## Purpose of Change – Base Unit

## **Re: Application for a Permissive Change Filing with FCC ID: EW780-0899-00**

### Main PCB front side

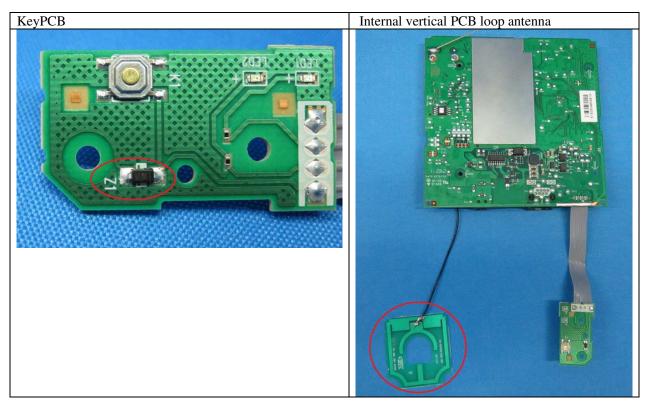
- 1. To add Registration Procedures on Base Unit of model C620
- 2. External vertical co-linear antenna will be changed to internal vertical PCB loop antenna.
- 3. Key PCB layout is changed and Z1 is changed to BZT52C6V2
- Base Main PCB layout is changed because Ethernet switch (U9), AR8236 is changed to (RTL8363NB with X2 Crystal 25MHz is deleted) and the POE controller IC (D025), TPS23753A is changed to SD4954B.
- 5. Regulator IC (U10), AP3406KT is added for Ethernet switch (U9), RTL8363NB.
- 6. Flash IC (UM11) is changed from W29N01HVSINF to S34ML01G200TF100.
- 7. DDR3 (UM9), EM6GC16E is changed to W631GU6NB-12.
- 8. RESET IC (U17), TPS3103E15DBVT is added.
- **9.** Adding an alternative AC adaptor (100-240VAC 50/60Hz 0.3A to 5VDC 2.0A 10.0W, Model: NBS12E050200UV, Brand: MASS POWER)
